Brooklyn Hill Cycling Improvements

Updated 90% Detailed Design Stage Safe System Audit

Prepared for:
Wellington City Council

Prepared by:
Stantec

Figure 2: Drawing Sheet C303 – Shared Path Marking

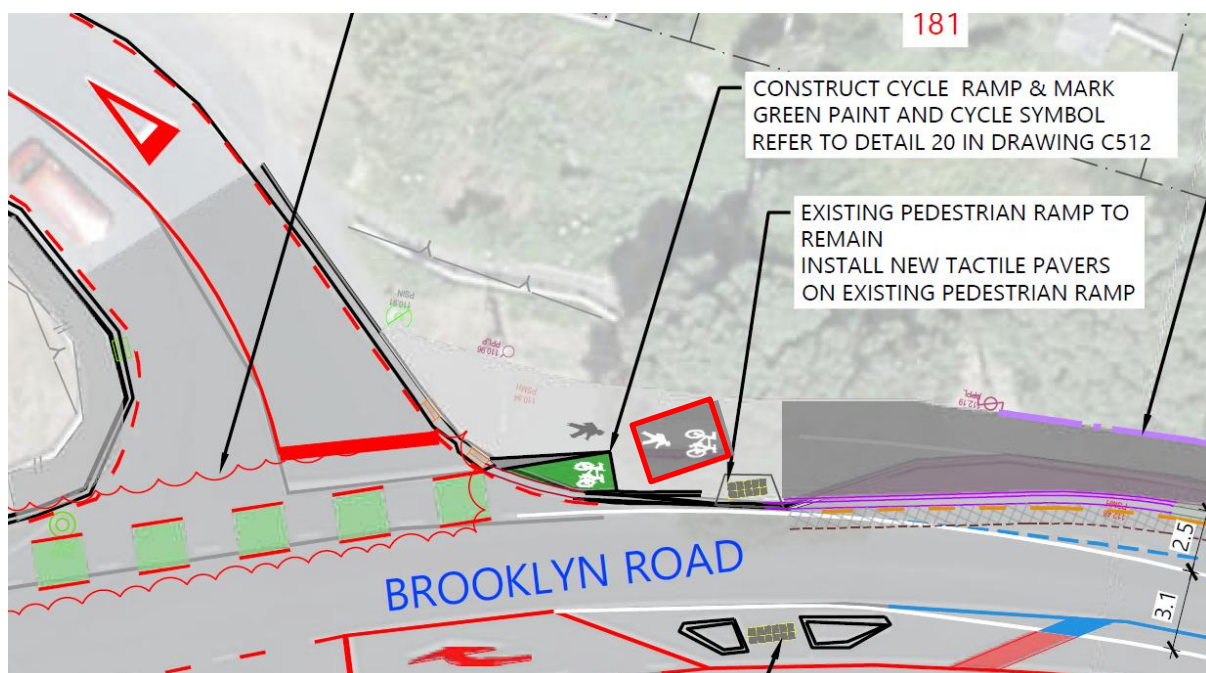
On drawing C303 the footpath and cycle way join on the western side of Washington Avenue (shown in **Figure 2** Error! Reference source not found.). There are no shared path markings or signage shown at this location in the provided plans. It is critical that to inform users that they are in a shared space to ensure that cyclists give way to pedestrians.

1. Apply road marking and signage at the start of the shared space to inform users that they are entering a shared path space.

Design team response	Agreed. Shared Path signs with supplementary “Begins” and “Ends” can be added at the start and end of the shared path, along with additional pavement markings to clearly inform users that they are entering a shared path.
Client safety engineer comment	Agree with Designer’s response.
Client decision	Agree with Designer and Client SE response
Action taken	An instruction will be issued to the designer to incorporate the required changes into the detailed design phase.

Figure 3: Drawing Sheet C303 – Shared Path by The Bus Stop west of Washington Avenue

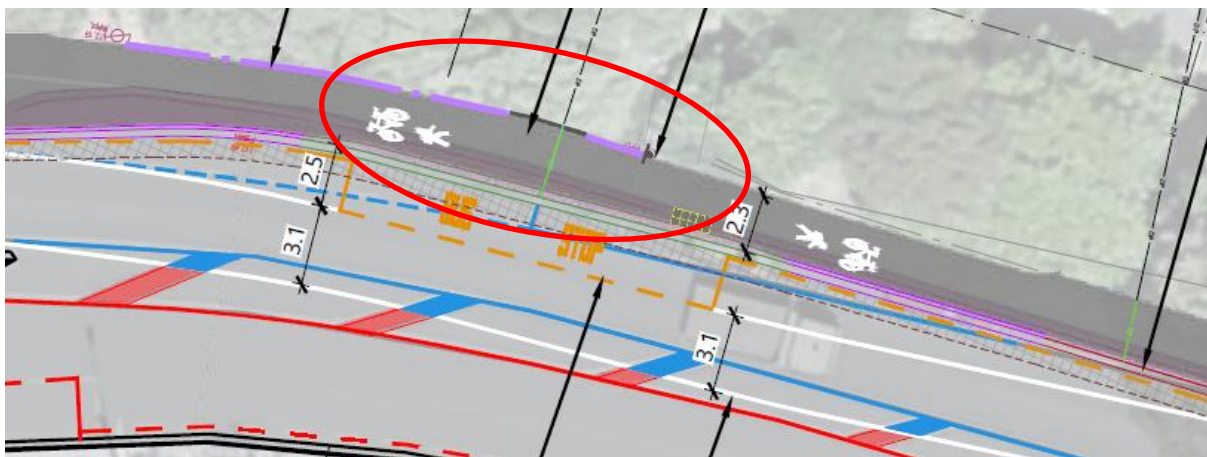
On drawing sheet C303, a shared path for pedestrians and cyclists is shown adjacent to the bus stop west of Washington Avenue. However, the absence of the banded red surfacing to highlight potential interactions (as shown in **Figure 3**Figure 6) may reduce awareness among users. Without this visual cue, cyclists may not anticipate pedestrians entering or exiting the bus, and pedestrians may not expect cyclists passing through the shared path. Previously the SSAT has been supplied with detailed design of the shared path section, this has not been provided in this set and the SSAT would like to highlight this to ensure that the banded red surfacing is installed in this shared path section next to the bus stop at the Bidwill Street intersection.

The severity is based on reduced user awareness due to the absence of red surfacing at the shared path, increasing the risk of conflict between cyclists (particularly electric bikes travelling uphill at a faster speed) and pedestrians near the bus stop.

1. Introduce banded red surfacing on the cycle path adjacent to the bus stop to warn cyclists of pedestrian activity.

Design team response	Agreed. The banded red surfacing pavement markings can be added on the shared path adjacent to bus stop.
Client safety engineer comment	Agree with Designer response.
Client decision	Agree with Designer and Client SE response
Action taken	An instruction will be issued to the designer to incorporate the required changes into the detailed design phase.

Figure 4: Drawing Sheet C303 - Pedestrian Facilities at Brooklyn Road & Washington Avenue Intersection

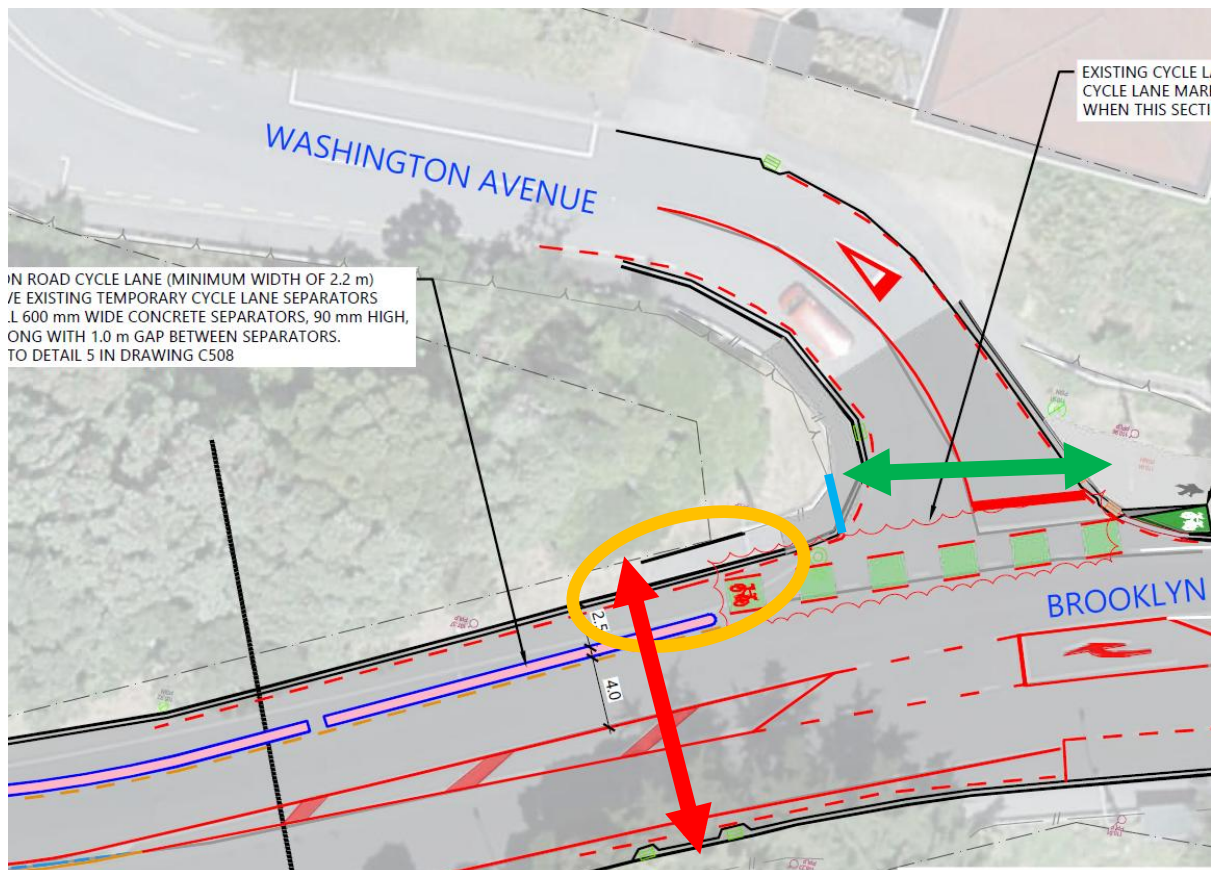
On drawing sheet C303, a footpath is shown southeast of the intersection between Brooklyn Road and Washington Avenue (as shown in **Figure 4**). This footpath in the orange circle could direct pedestrians to an area that is a dead end and then create a situation where they try to cross the new cycleway, separator and Brooklyn Road where the red arrow is shown. Furthermore Brooklyn Road does not have a safe median refuge in this area. This could place pedestrians in a dangerous crossing situation with tripping hazards and the lack of a pedestrian refuge.

The safer place for pedestrians to cross Washington Avenue is at the green arrow and then they can use the dedicated pedestrian crossing point with median refuge island to then cross Brooklyn Road.

However the SSAT also noticed that there are no dropped kerbs provided on the footpaths on each side of Washington Avenue and it does not appear that drawing C303 makes provision for dropped kerbs or a crossing point. This could result in pedestrians tripping when crossing Washington Avenue, furthermore it will cause difficulty for visually impaired pedestrians as well as wheelchair users to cross Washington Avenue safely in this vicinity.

1. Install dropped kerbs on Washington Avenue to provide a crossing point for pedestrians;
2. Remove the footpath section shown in orange to prevent pedestrians becoming trapped and wanting to cross Brooklyn Road at the dead end; and
3. Consider extending the sight rail where the blue line is shown to further direct pedestrians to utilise the safer crossing point on Brooklyn Road.

Design team response	Agreed. An informal pedestrian crossing (dropped kerbs on Washington Avenue) adjacent to the cycle lane crossing can be investigated. However, the provision of such a crossing is outside the current scope of this project. Agreed. The section of footpath on Brooklyn Road leading to the dead end (highlighted in orange in the above image) can be removed to discourage pedestrians from becoming trapped and attempting to cross Brooklyn Road at the dead-end location. Agreed. A fence can be added across the footpath leading to the dead end to guide pedestrians approaching from the northern Washington Avenue footpath to cross Washington Avenue and use the safer crossing point on Brooklyn Road.
Client safety engineer comment	Agree with Designer response,
Client decision	Agree with Designer and Client SE response
Action taken	An instruction will be issued to the designer to incorporate the required changes into the detailed design phase. The informal pedestrian crossing (dropped kerbs on Washington Avenue), adjacent to the cycle lane crossing, will be referred to the maintenance team for consideration as part of future maintenance planning.

Figure 5: Drawing Sheet C302 - Missing Tactile Pavers

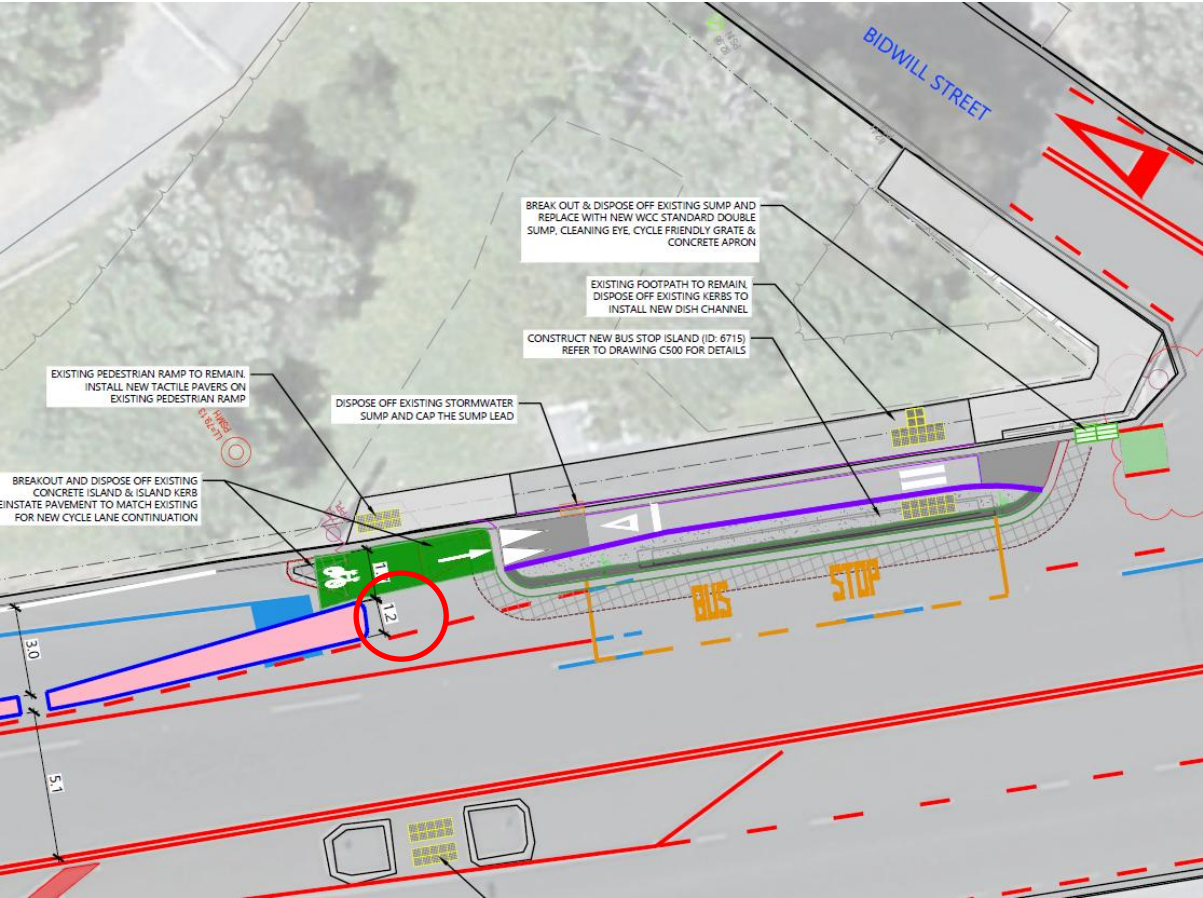
On drawing sheet C302, on Brooklyn Road just north of the intersection with Bidwill Street, there is a pedestrian crossing point with tactile pavers on the footpath only (as shown in **Figure 5**), once the pedestrian has crossed the cycle way there is a small refuge before the bus entry taper. Due to the distance of the crossing past a refuge island this may create ambiguity for both visually impaired pedestrians not identifying the risk of stepping into the bus entry taper zone.

- 1. Add additional warning tactile pavers.

Design team response	Agreed. Additional tactile pavers can be added at the location highlighted in the image above.
----------------------	--

Client safety engineer comment	Agree with Designer response.
Client decision	Agree with Designer and Client SE response
Action taken	An instruction will be issued to the designer to incorporate the required changes into the detailed design phase.

Figure 6: Drawing Sheet C302 – Shared Path by The Bus Stop north of Bidwill Street

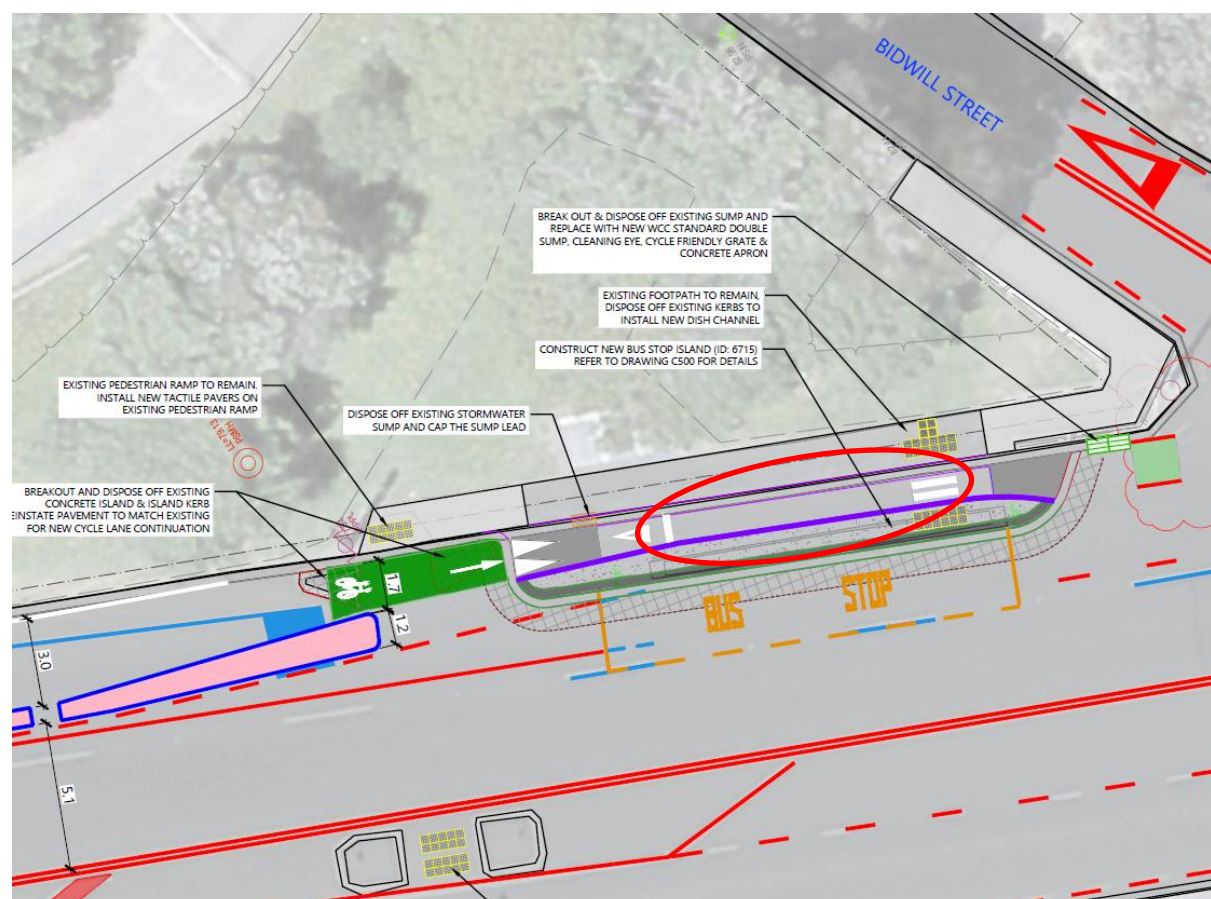
On drawing sheet C302, a shared path for pedestrians and cyclists is shown adjacent to the bus stop north of Bidwill Street. However, the absence of red surfacing to highlight potential interactions (as shown in **Figure 6**) may reduce awareness among users. Without this visual cue, cyclists may not anticipate pedestrians entering or exiting the bus, and pedestrians may not expect cyclists passing through the shared path. Previously the SSAT has been supplied with detailed design of the shared path section, this has not been provided in this set and the SSAT would like to highlight this to ensure that the banded red surfacing is installed in this shared path section next to the bus stop at the Bidwill Street intersection.

1. Introduce banded red surfacing on the cycle path adjacent to the bus stop to warn cyclists of pedestrian activity and ensure the white crossing line is flush with the surface to prevent trip hazards.

Design team response	The red pavement surfacing marking along the full length of the cycle bypass adjacent to the bus stop is already shown on Drawing C500 of the detailed design set, which was not included in the drawings provided to the SSAT.
Client safety engineer comment	Agree with Designer response.
Client decision	Agree with Designer and Client SE response
Action taken	No action is required as this has been addressed on another drawing.

Figure 7: Drawing Sheet C306 – Speed Hump Signs next to Vegetation

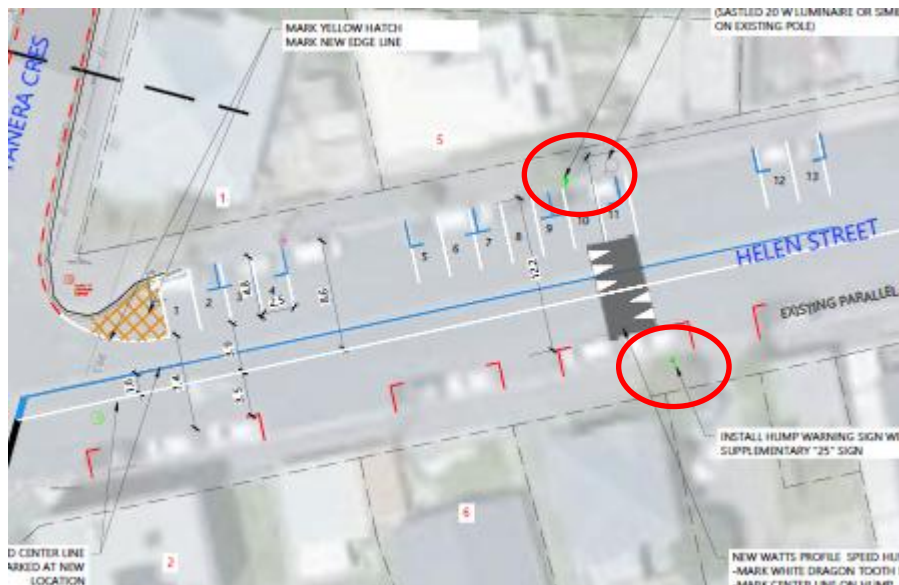
Drawing sheet C306 indicates that speed hump signs are to be installed at the new humps (as shown in **Figure 7**). The signs are proposed to be placed in proximity to existing trees, if such signs are not visible to approaching drivers it could cause them to not anticipate the vertical deflection in the road and this could lead to a loss of control and potential crash.

1. Ensure signs are placed clear of vegetation.

Design team response	Agreed, the sign placement shall be to make sure that it is clear of vegetation. In addition to the signs, the speed humps are supplemented with raised hump pavement markings to enhance driver awareness of the presence of the speed hump.
Client safety engineer comment	Agree with Designer response.
Client decision	Agree with Designer and Client SE response
Action taken	This will be addressed with the contractor during the construction phase.
